COUNCIL ASSESSMENT REPORT

Panel Reference	PPSSNH-23
DA Number	DA 2018/273/A
LGA	WILLOUGHBY
Proposed Development	Section 4.55 - Changes to floor space ratio, building footprint, internal and external alterations, landscaping and associated works.
Street Address	3 Broadcast Way, ARTARMON
Applicant/Owner	Lindsay Bennelong Development Pty Ltd
Date of DA lodgement	13 August 2019
Number of Submissions	Nil
Recommendation	Approval
Regional Development Criteria (Schedule 7 of the SEPP (State and Regional Development) 2011	Capital investment value (CIV) of over \$30 million
List of all relevant s4.15(1)(a) matters	<ul style="list-style-type: none"> • Willoughby Local Environmental Plan 2012 • Willoughby Development Control Plan • State Environmental Planning Policy No.55-Remediation of Land • State Environmental Planning Policy (Infrastructure) 2007 • State Environmental Planning Policy No.33 – Hazardous and Offensive Development • Sydney Regional Environmental Plan (Sydney Harbour Catchment) 2005

SNPP NO: PPSSNH-23
COUNCIL: WILLOUGHBY CITY COUNCIL
ADDRESS: 3 BROADCAST WAY, ARTARMON NSW 2064.
DA NO: DA-2018/273/A
PROPOSAL: SECTION 4.55 - CHANGES TO FLOOR SPACE RATIO, BUILDING FOOTPRINT, IN

Plan 1: Lower ground floor plan

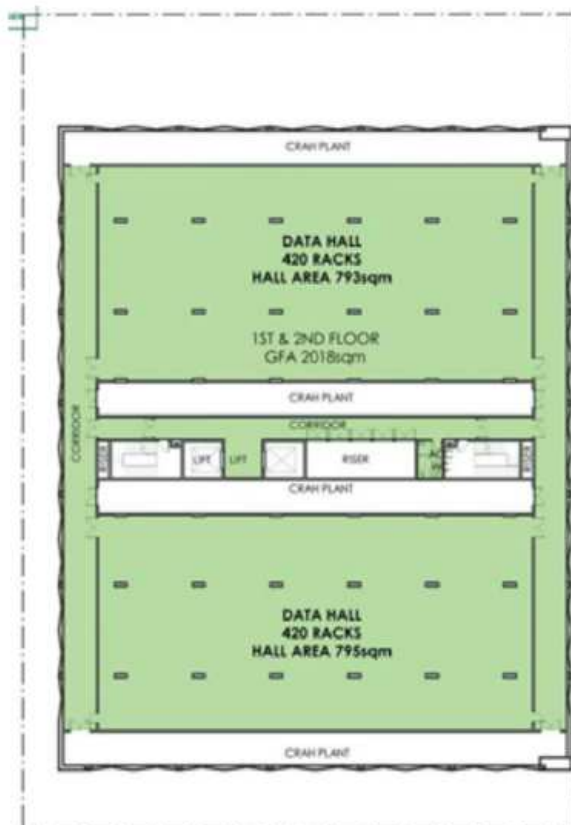
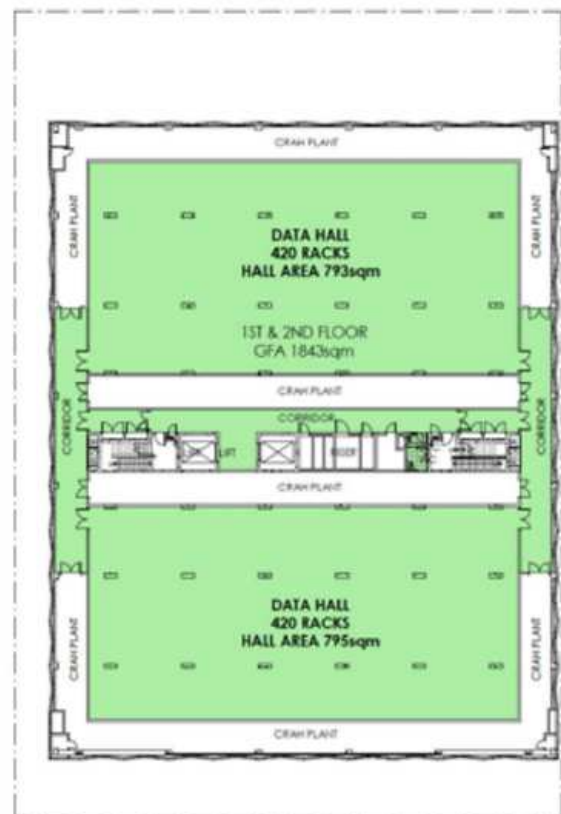
- Lower ground floor (Plan 1)
 - Realignment of the setback on the northwest elevation with the ground floor level to a new increased setback of 4.6m to allow for a new Ausgrid easement along the north-western boundary;

- New water tanks and service corridor below ground floor level adjacent to the lifts;
 - Relocation of the original underground fuel tank and pump room to within 4-hour above ground fire rated enclosure;

- Reconfiguration of the switch rooms/plant rooms layout to facilitate the fuel tank and pump room.
- Ground floor (Plan 2)
 - Reconfiguration of the administration areas results in the reduction in gross floor area by 18m²;

Plan 2: Ground floor plan

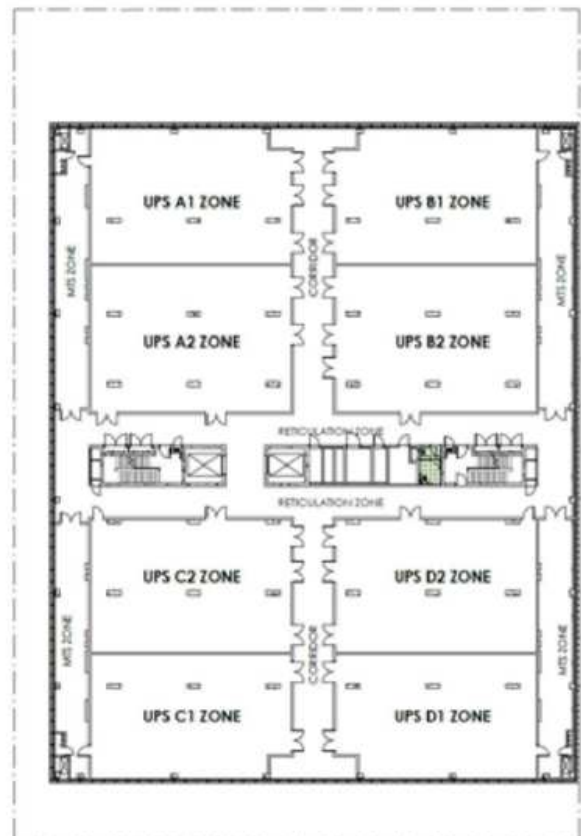
- Increase in the floor to ceiling height from 4.5m to 5m;
- First and second floors (Plan 3)
 - Minor increase in the perimeter of the plant area results in a reduction in gross floor area by 175m² on each floor;

Plan 4: Third floor plan

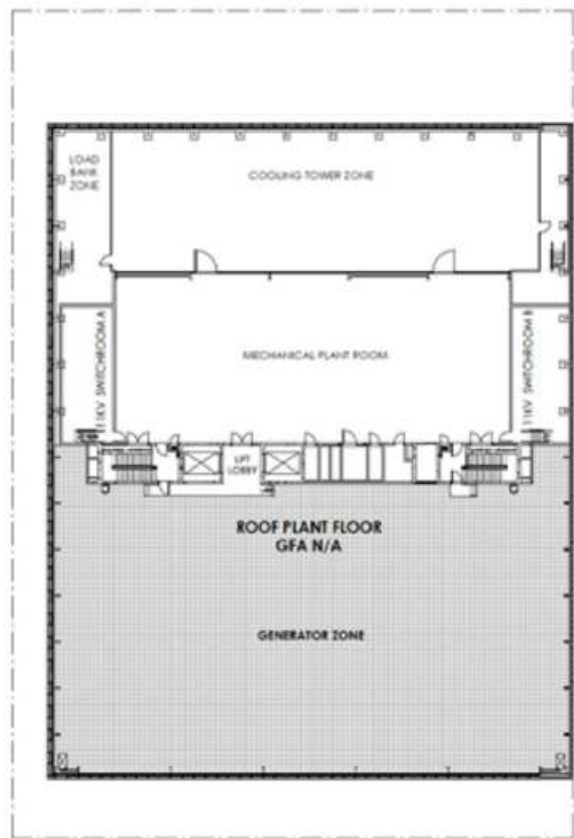
- Third floor (Plan 4)
 - Reconfiguration of the uninterrupted power supply layout;
 - Provision of new amenities results in an increase in gross floor area by 7m²;

- Reduction in floor to ceiling height from 4.5m to 4m;
- Fourth floor (Plan 5)
 - Reconfiguration of the buffer tank to allow for new plant rooms/storage;
